# CITIZENS GENERAL HOSPITAL

Mail Control No: 03349  
License No: 37-09016-01

In reference to your letter of May 21, 1985, concerning our application dated January 10, 1985, the responses to your requests for additional information are as follows:

Citizens General Hospital  
New Kensington, PA  
Nuclear Medicine  
(not to scale)

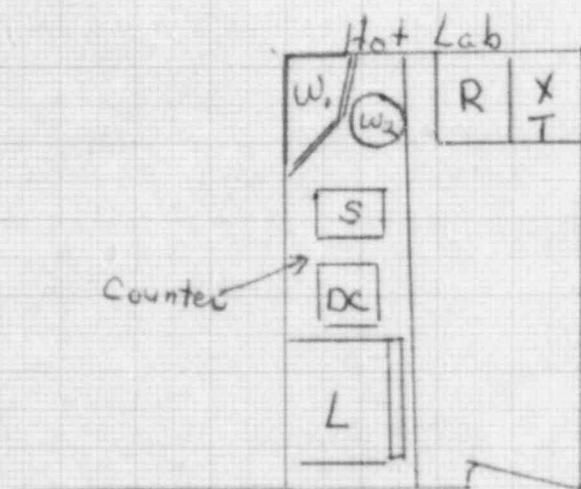
1. Please note that the Nuclear Medicine area has moved since the application. The new area with shielding is attached.

note: flow rates in red are measured  
See response to item 3

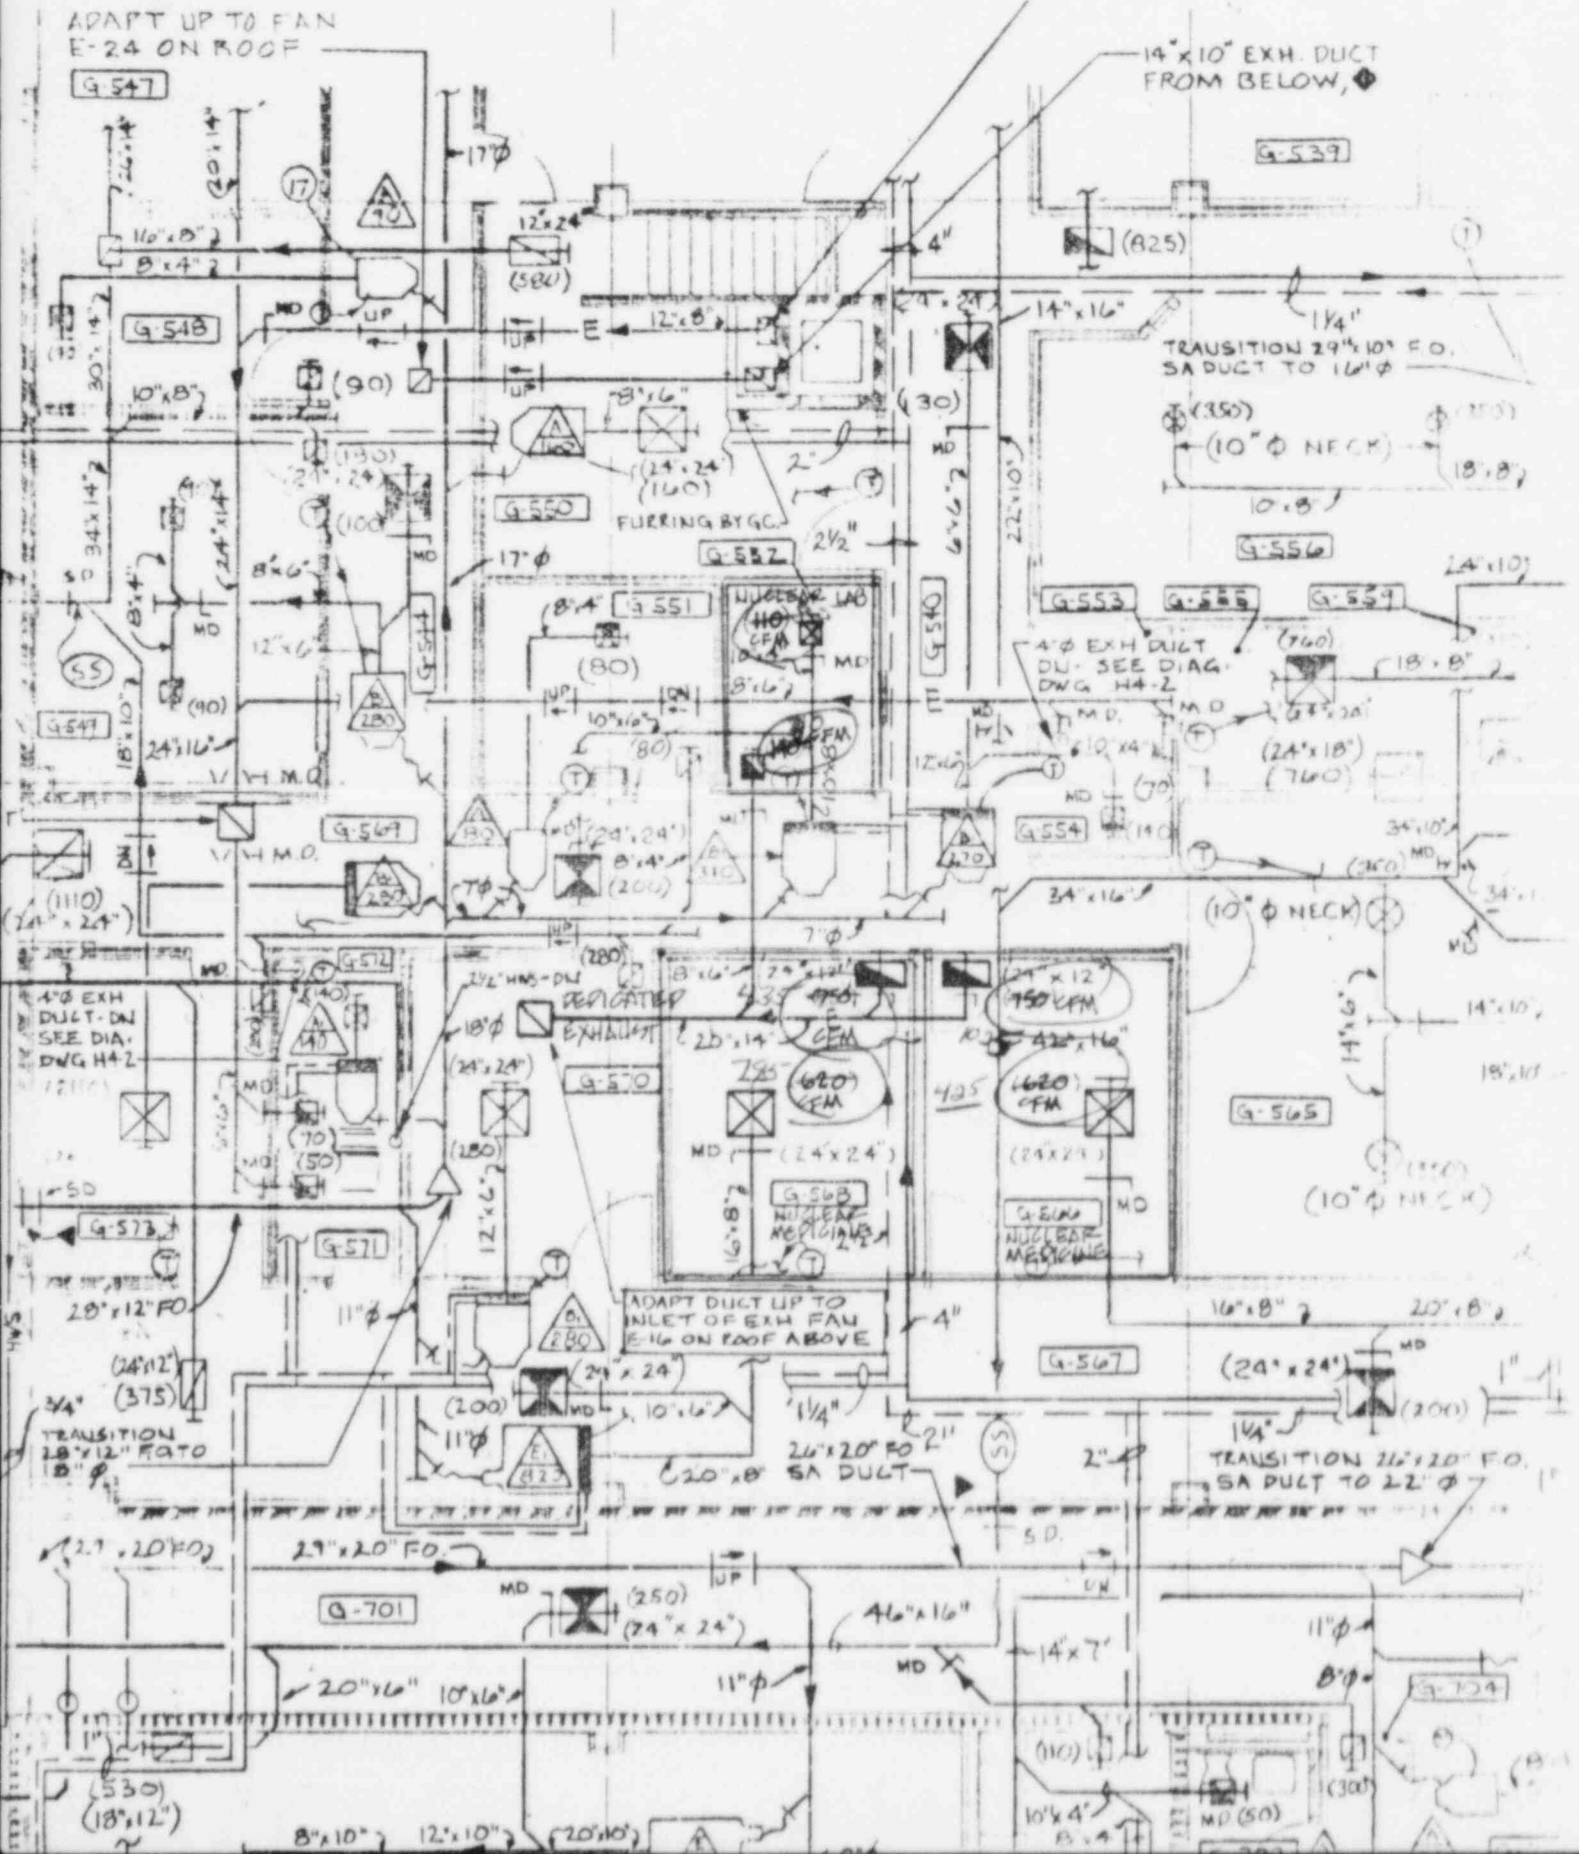
3. Airflow measurements of the new area have been done.

The flow rates are 85 cfm supply and 310 cfm exhaust for the Hot Lab; 425 cfm supply and 1025 cfm exhaust for the Scan Room; and 435 cfm supply and 795 cfm exhaust for the office. Measurements were made on August 12, 1985, by
